Access Compliance Report

Public Rights-of-Way

Intersection ID: 4697	Main Street: BELLA_VISTA_CT	Cross Street: REAMES_RD	Location: SW
ADA ID: 9ACD5E61C57E	Ramp Type: Perp	Initial Pass/Fail: Fail	Overall Compliance: No
Severity Score: 31.25			
Codes/Mitigation Info/Possible Solution		Field Measurements/Component Compliance

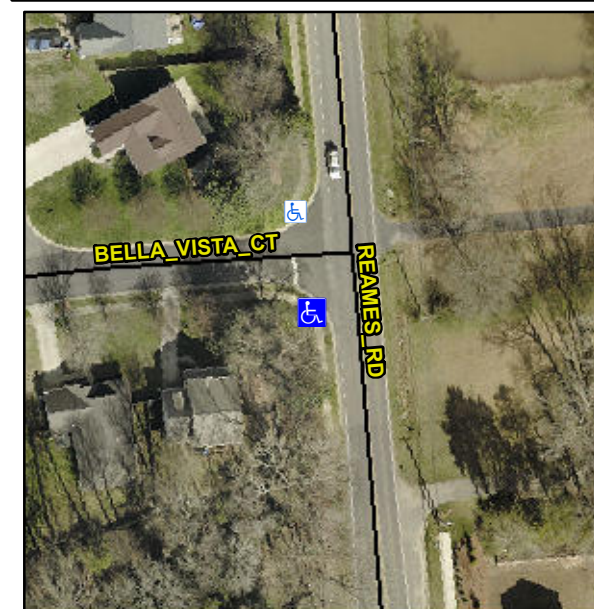
Not Found, R304.5.1, R304.2.2, R304.5.3

Compliance	Description	Data	Compliance	Description	Data
N/A	Ramp Length (in)	24.8	No	Ramp Slope (%)	8.6
No	Ramp Width (in)	34.0	No	Ramp XSlope (%)	4.0
N/A	Flare Type LT	N/A	N/A	Flare Type RT	N/A
N/A	Flare Slope LT (%)	N/A	N/A	Flare Slope RT (%)	N/A
N/A	Flare Traversable LT?	N/A	N/A	Flare Traversable RT?	N/A
N/A	Landing Length (in)	N/A	N/A	DWS Provided?	N/A
N/A	Landing Width (in)	N/A	N/A	DWS Contrast?	N/A
N/A	Landing Slope (%)	N/A	N/A	DWS Length (in)	N/A
N/A	Landing X Slope (%)	N/A	N/A	DWS Full Width?	N/A
N/A	Landing Curb? (Y/N)	N/A	N/A	DWS Offset (in)	N/A
N/A	Shared Landing?	N/A			
N/A	Gutter Ponding?	N/A	N/A	Gutter Slope (%)	N/A
N/A	Gutter Lip Ht (in)	N/A	N/A	Gutter X Slope (%)	N/A
N/A	Painted X Walk1?	No	N/A	Painted X Walk2?	N/A
	X Walk 1 Direction	To NW		X Walk 2 Direction	N/A
N/A	X Walk 1 Width (in)	N/A	N/A	X Walk 2 Width (in)	N/A
	X Walk 1 Slope (%)	1.9		X Walk 2 Slope (%)	N/A
	X Walk 1 X Slope (%)	4.4		X Walk 2 X Slope (%)	N/A

Remove & Replace Entire Ramp.
